Sicherheitsmitteilung SM JAHRMONATZAHL

Service bulletin number: 20180301-V2

Subject: Safire 3 Brake Line Configuration Modification And Mandatory Inspection

SAFIRE 3 MODIFICATION GUIDE BRAKE TAB INSTALMENT: REVISION 4, JULY 2025

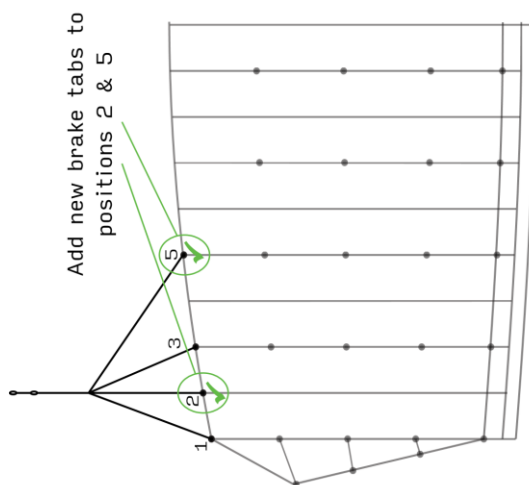
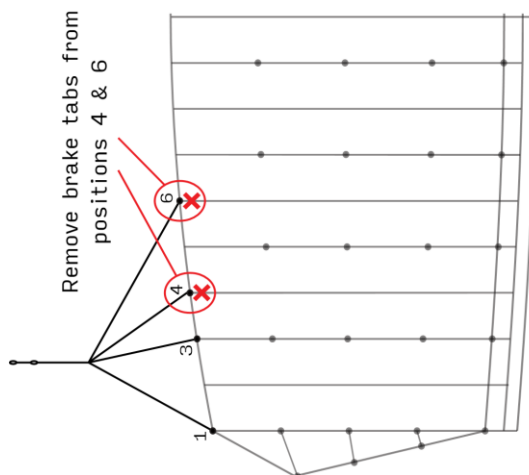
NEW BRAKE TABS CONFIGURATION

Add new brake tabs to
positions 2 & 5

EXISTING BRAKE TABS CONFIGURATION

Remove brake tabs from
positions 4 & 6

- Brake tabs are installed at the 1-2-3-5 positions.
- Canopy has been relined with the latest lineset, this can be verified by checking if the A1 and A2 lines are the same length.

If either check fails, the canopy should be grounded until the canopy has been updated to the current configuration with the help of your local rigger or JYRO. You can request a free modification kit from the JYRO Sales team. This includes the current lineset and extra brake tabs. The modification entails removing brake tabs at positions 4 & 6, and installing new tabs at positions 2 & 5. The canopy should be relined with the current lineset. The old lineset must be disposed of.

NOTE: Brake tab positions are numbered along each rib, starting with the outside corners of the tail as position 1.
